4.1 Conclusions	4-1
4.2 Recommended Scope and Budget for Fiscal Year 2014-15	4-2
4.3 Recommendations for Changes to the MZ-1 Plan.....	4-3
Section 5 – Glossary	5-1
Section 6 – References	6-1
Appendix A – Monitoring Data through December 2013	
Appendix B – Comments and Responses

Land Subsidence Committee
 2013 Annual Report

Figure 3-7

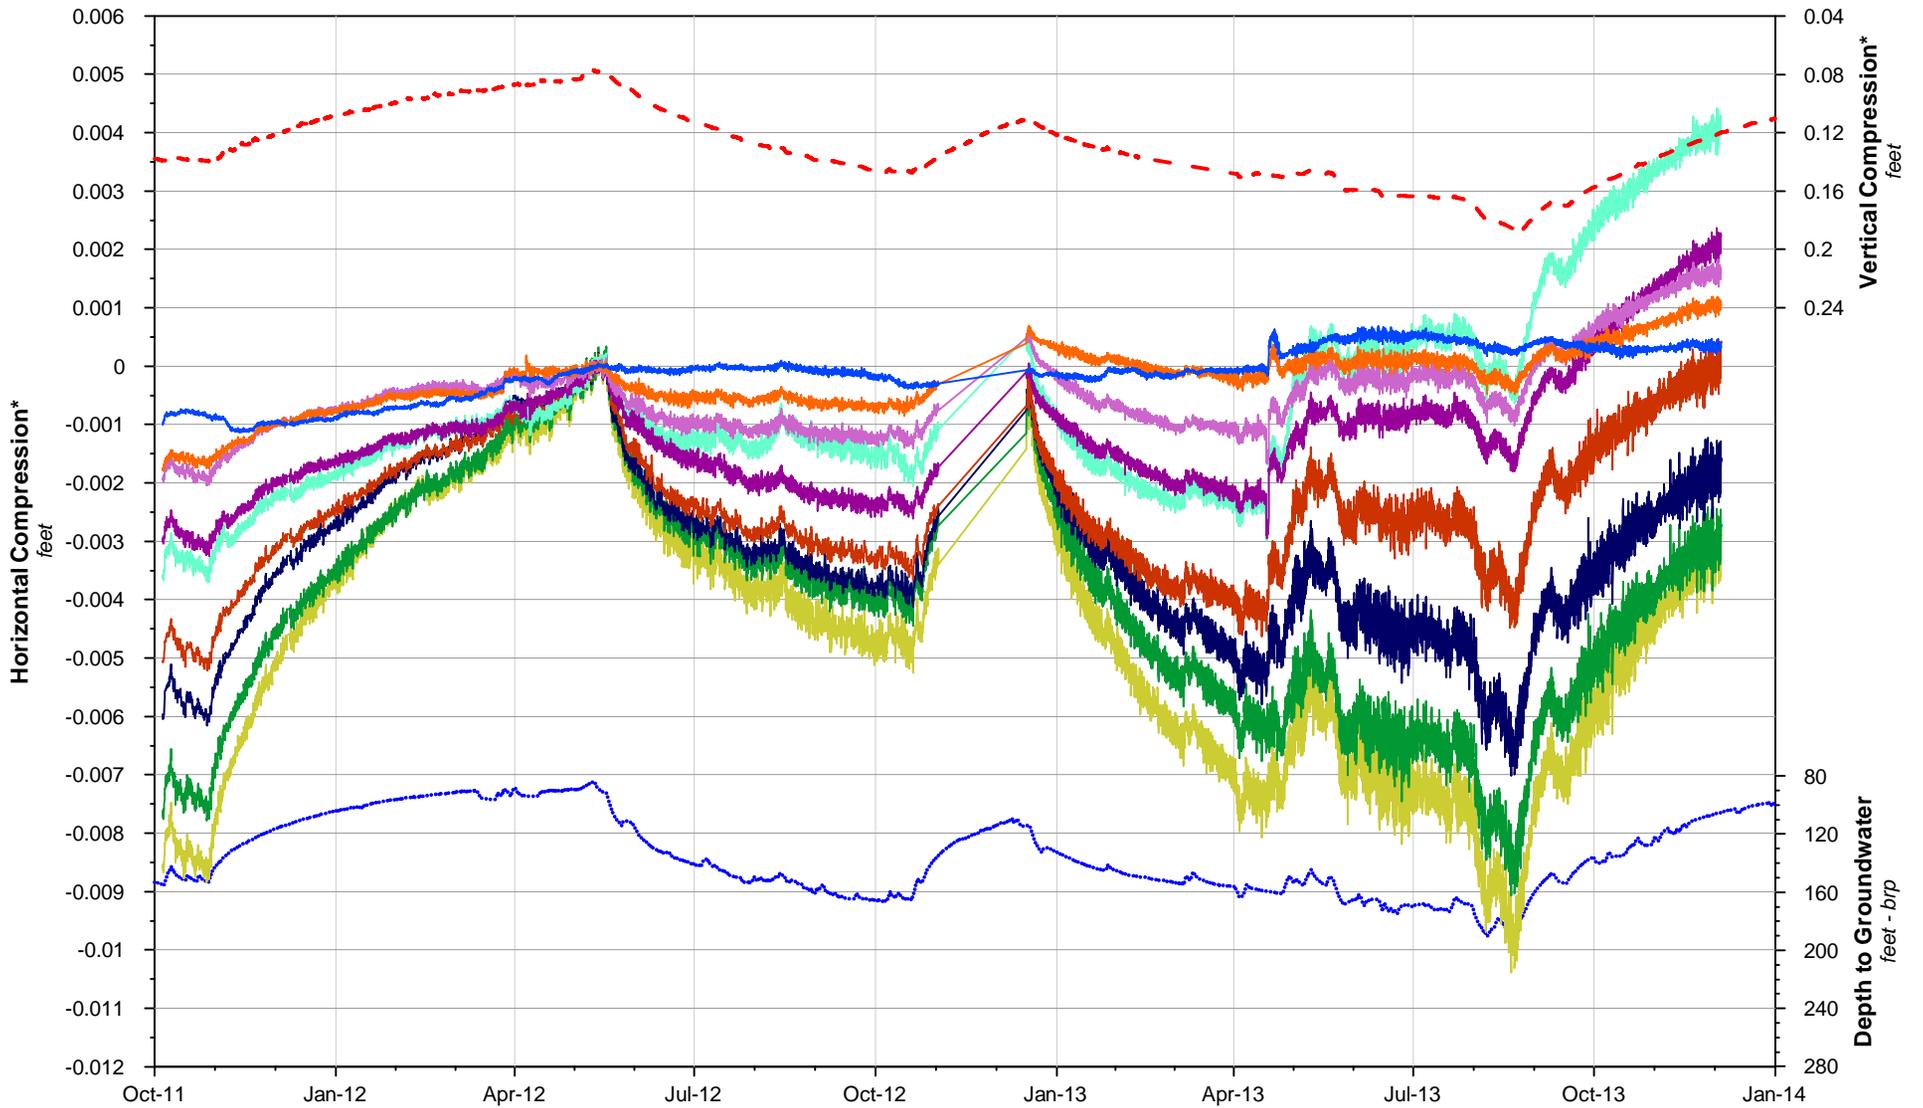
5	Figure 3-7	The horizontal strain is accumulated for each segment of the extensometer from west to east, though it seems like the strain for each segment should be plotted individually normalized such as foot of strain/length of rod (ft/ft) times some fixed scalar to better show the zones where strain is greatest/least.	Figure 3-8 was added to show individual strain across each segment of the Daniels Horizontal Extensometer.

Figure 3-9

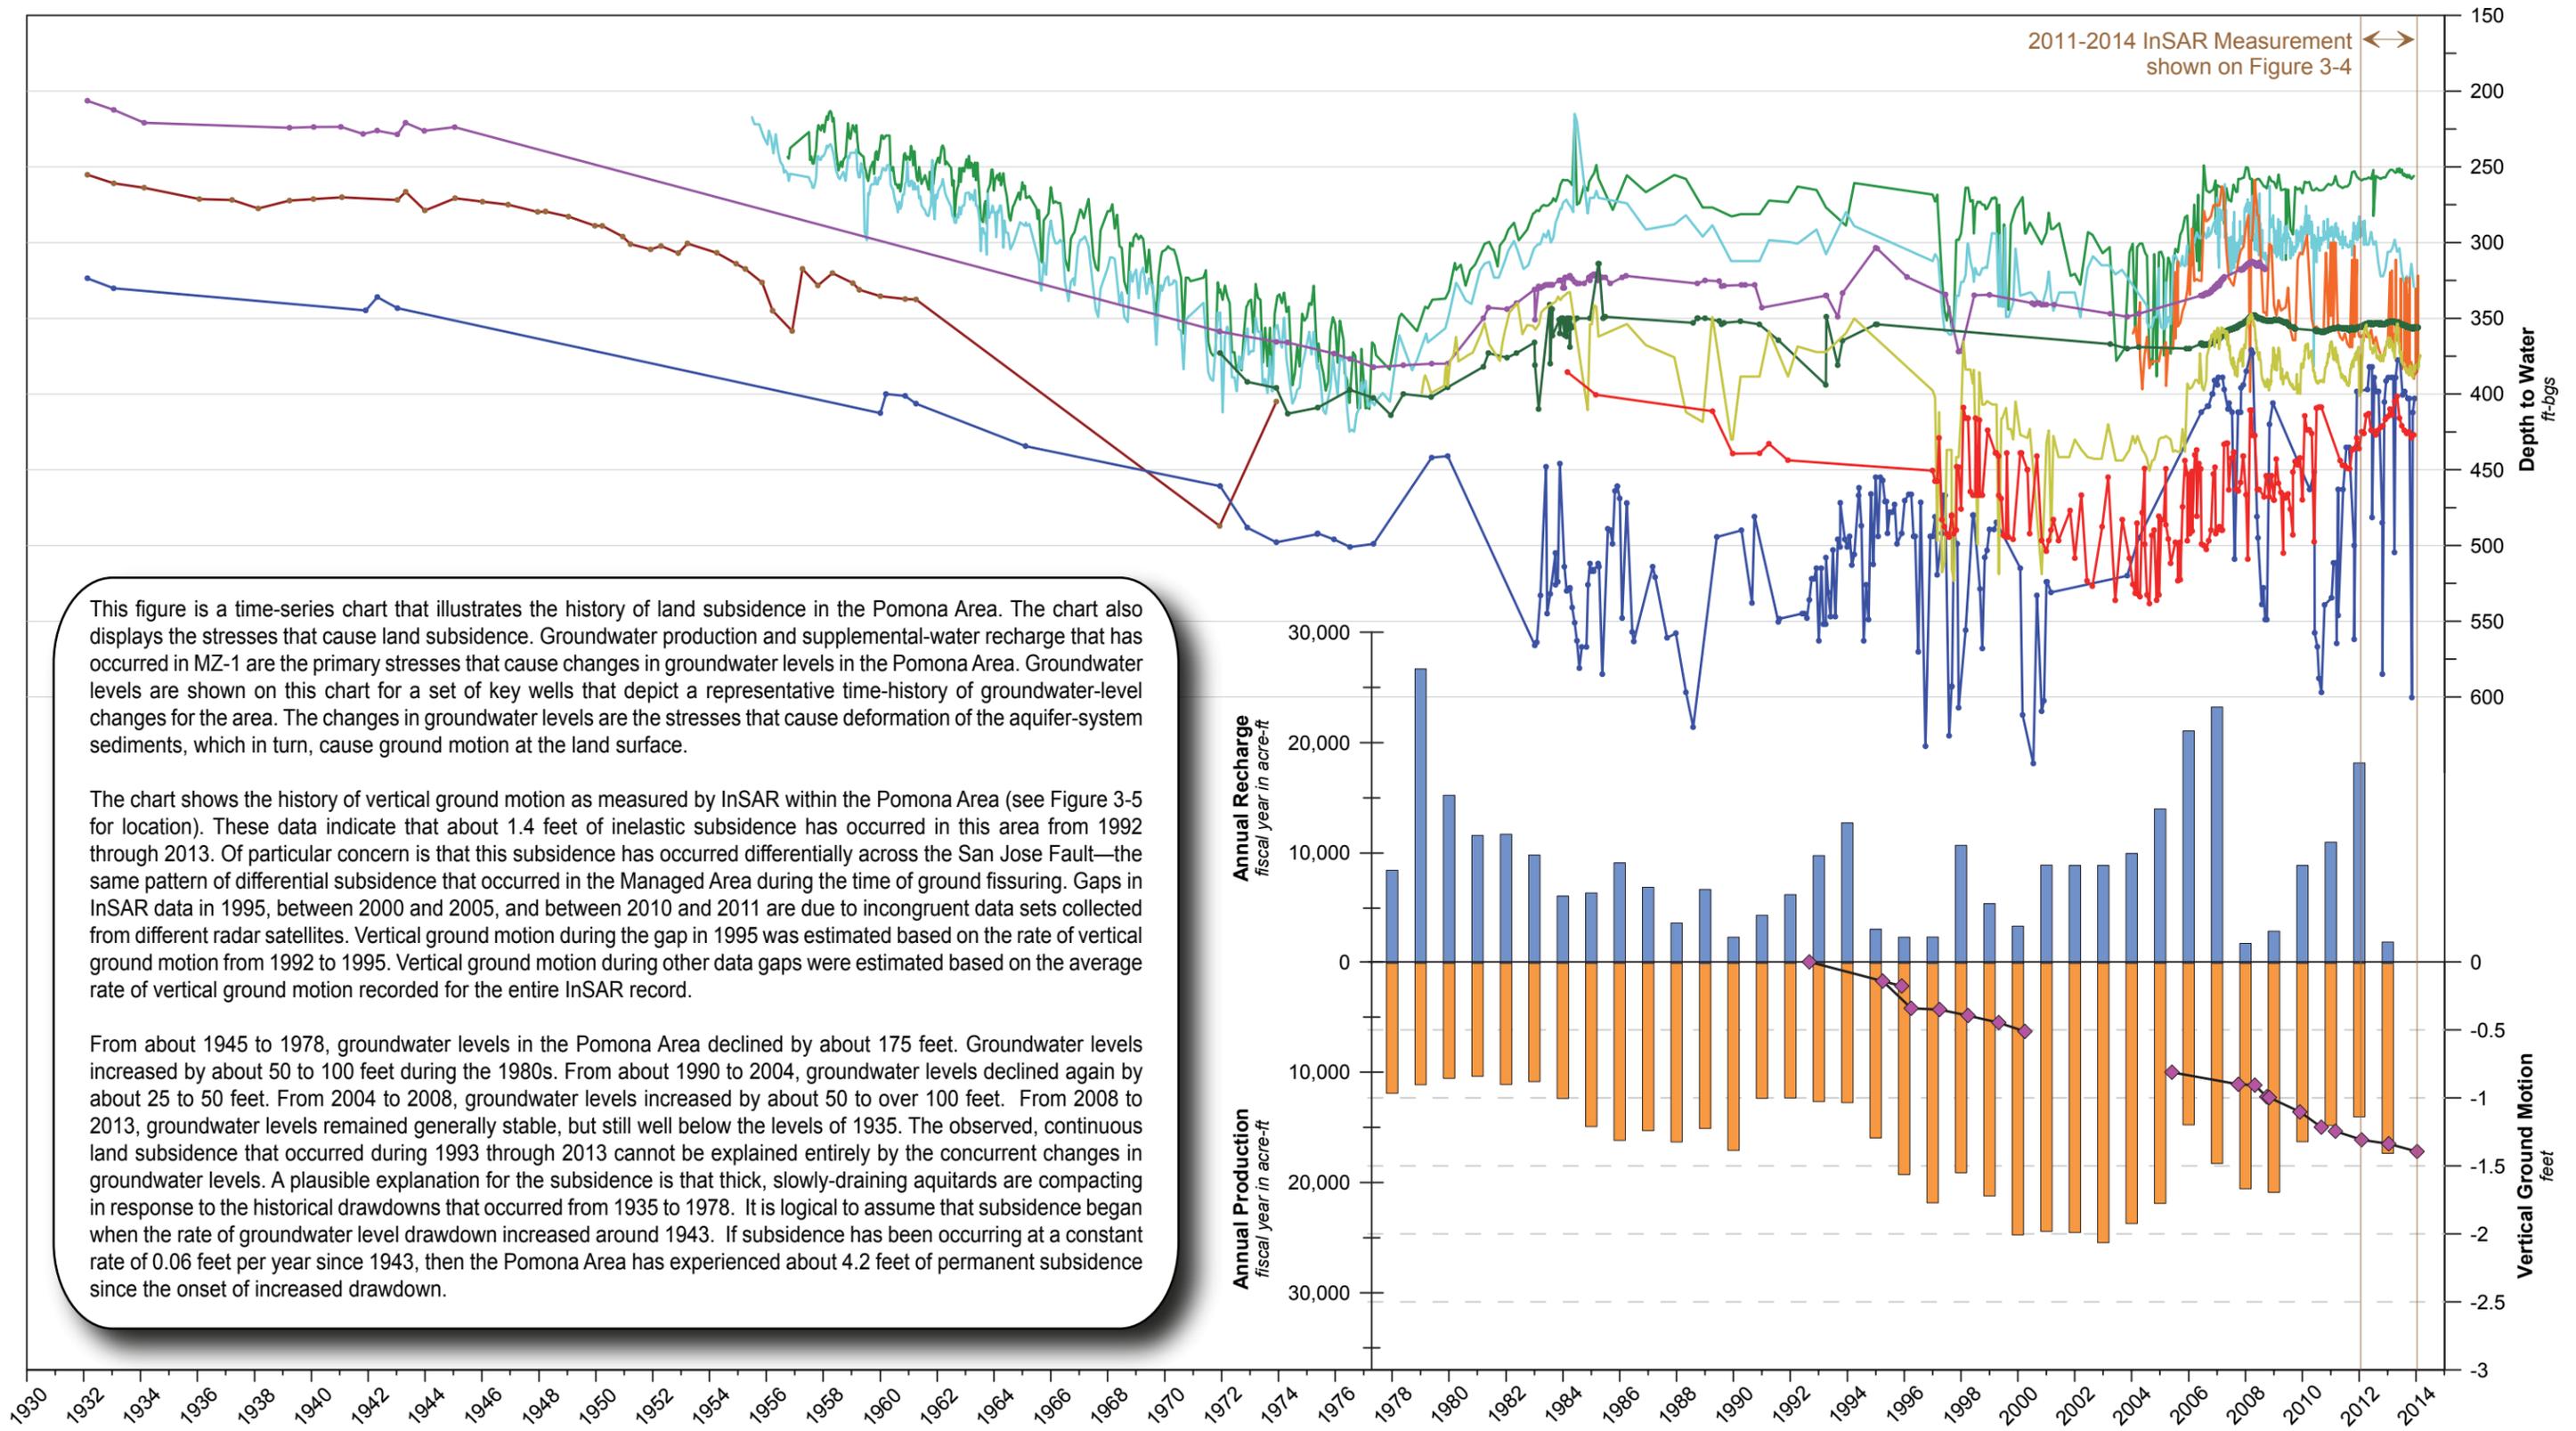
Comment Number	Reference	Comment	Response
5	Page 3-4 and figure 3-9	An estimate of a potential for 4.2 feet of permanent subsidence in the Pomona/San Jose fault area is given but is explained as being based on an extrapolated rate of -0.06 feet/year. The text on page 4-1 states, "It is likely that about 4.2 feet of permanent, differential subsidence has occurred in this area since the onset of increased drawdown in the 1940s." This latter statement may suggest a greater degree of certainty in the estimate than indicated by the previous statements and by the available data.	Comment addressed in report on Page 4-1: The identified sentence was replaced with: "It is logical to assume that at least 4.2 feet of permanent, differential subsidence has occurred in this area since the onset of increased drawdown in the 1940s."
6	Table 3-1	Well Xref8730. This well is located in the Managed Area but does not appear on any of the figures. Note 1 in the table indicates that the well screen interval for this well is unknown but it is placed in the category of wells screened in the Shallow aquifer layer for the purpose of tabulation. Suggest expanding on note 1. Example - Perforated interval of well is unknown but assumed to be shallow based on typical well construction for other wells in the general vicinity.	This well is not on any figures because the wells that produced groundwater during 2013 are not displayed on any figures. Text was added to Note 1 of Table 3-1 to address this comment.
